Site Accessibility Evaluation

Fire Station 5

SUBJECT: Fire Station 5 Self-Evaluation

Finding: 1

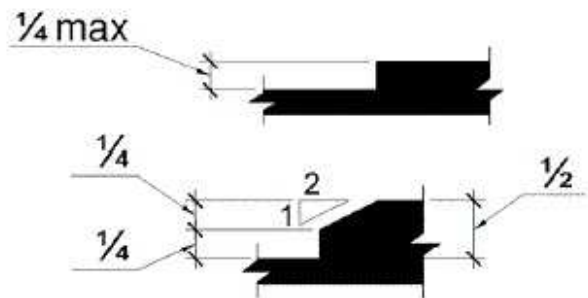
The front entrance has a 5" step and a 1-1/2" threshold to enter the building.

1/4 inch is the maximum vertical rise. Changes in level between 1/4 inch and 1/2 inch must be beveled at 1:2 or less. Changes in level greater than 1/2 inch must be by way of a ramp.

2010 ADAS Section 303.3

There is not an accessible entrance to the fire station.

Due to the age and configuration of the station, leave as is. However, staff must be ready, willing and able to assist someone outside or open bay doors to provide service.

Finding: 2

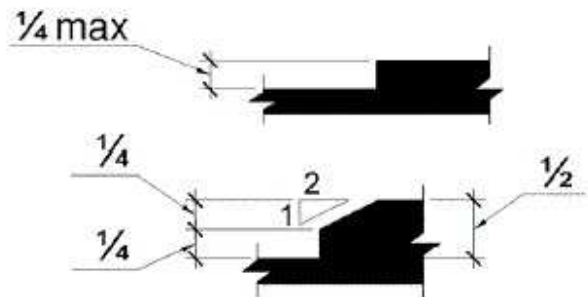
The side entrance has a 3-3/4" step and a 1" threshold to enter the building.

1/4 inch is the maximum vertical rise. Changes in level between 1/4 inch and 1/2 inch must be beveled at 1:2 or less. Changes in level greater than 1/2 inch must be by way of a ramp.

2010 ADAS Section 303.3

There is not an accessible entrance to the fire station.

Due to the age and configuration of the station, leave as is. However, staff must be ready, willing and able to assist someone outside or open bay doors to provide service. Add sign with arrow indicating to ring front bell for service.

Finding: 3

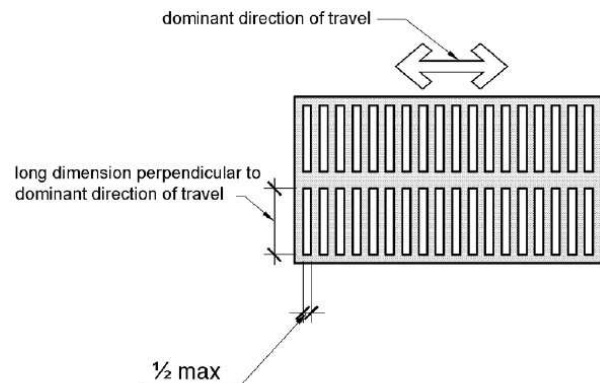
The concrete expansion joint is spaced greater than a 1/2 inch.

Openings in floor or ground surfaces shall not allow passage of a sphere more than 1/2 inch diameter. Elongated openings shall be placed so that the long dimension is perpendicular to the dominant direction of travel.

2010 ADAS Section 302.3

The sidewalk leading to the entrance on W. Colorado Avenue has a 1" deep by 2" wide gap.

N/A - Refer to Finding

Finding: 4

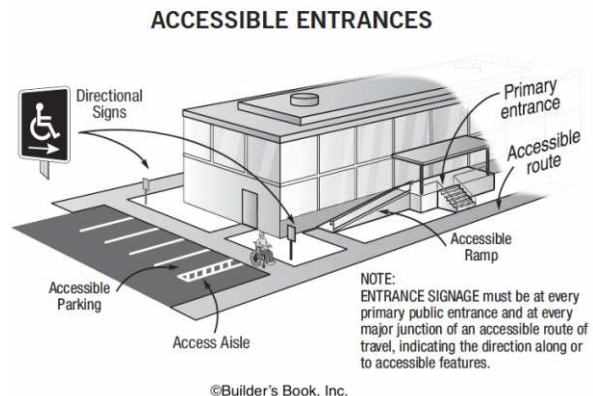
Seven of the concrete pads are spalling 1/2" to 3/4" deep. The concrete pads are approximately 4'-0" by 4'-0", for a total of about 28 linear feet of concrete requiring replacement.

There is no accessible route of travel from the public way.

At least one accessible route shall be provided within the site from accessible parking spaces and accessible passenger loading zones; public streets and sidewalks; and public transportation stops to the accessible building or facility they serve.

The sidewalk on 29th Street has 7 concrete pads with spalling.

Remove and replace sidewalk panels.

Finding: 5

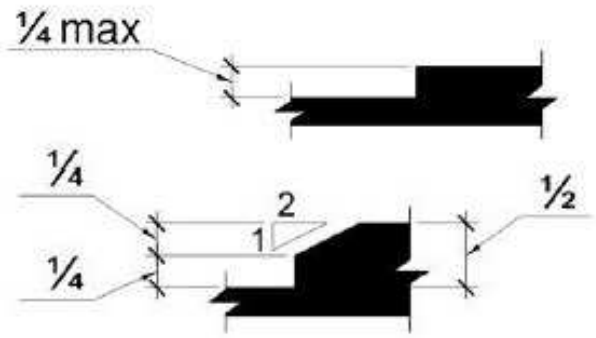
The walkway contains abrupt vertical edges and/or variations over a 1/4 inch.

1/4 inch is the maximum vertical rise. Changes in level between 1/4 inch and 1/2 inch must be beveled at 1:2 or less.

2010 ADAS Section 303.3

There is a 2-3" tall curb at the driveway, without a curb ramp.

Add a curb ramp/transition.

Finding: 6

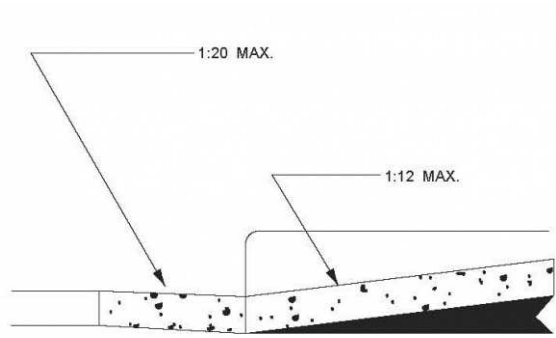
The transition from the curb ramp to the walk, gutter or street is not flush and free of abrupt changes in level.

Transitions from ramps to walks, gutters or streets shall be flush and free of abrupt change. Maximum slopes of adjoining gutters, road surface immediately adjacent to the curb ramp, or accessible route shall not exceed one unit vertical in 20 units horizontal (5-percent slope).

2010 ADAS Section 406.2

The pie-shaped area between the curb ramps is deteriorating.

Replace the pie-shaped area.

As of April 2019, the corner are had been replaced.

Finding: 7

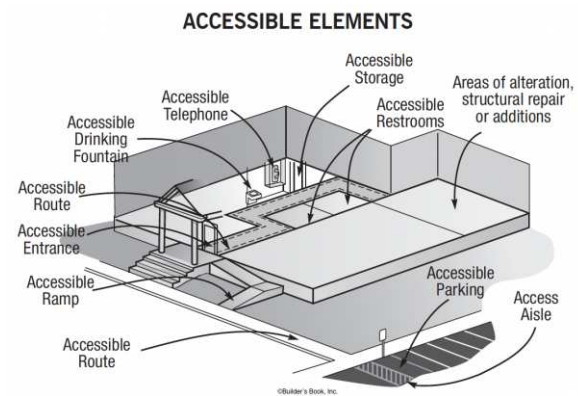
There is no accessible route to the room near the front entrance where blood pressure checks are performed, due to the step at the front entrance and numerous level changes within the building.

At least one accessible route shall be provided to accessible facilities, accessible elements, and accessible spaces that are on the same site. The clear width must be a minimum 36 inches.

2010 ADAS Section 206.2.2

The room near the front entrance is not accessible.

Perform blood pressure checks in the bay area, as there is not a threshold issue at the bay doors.
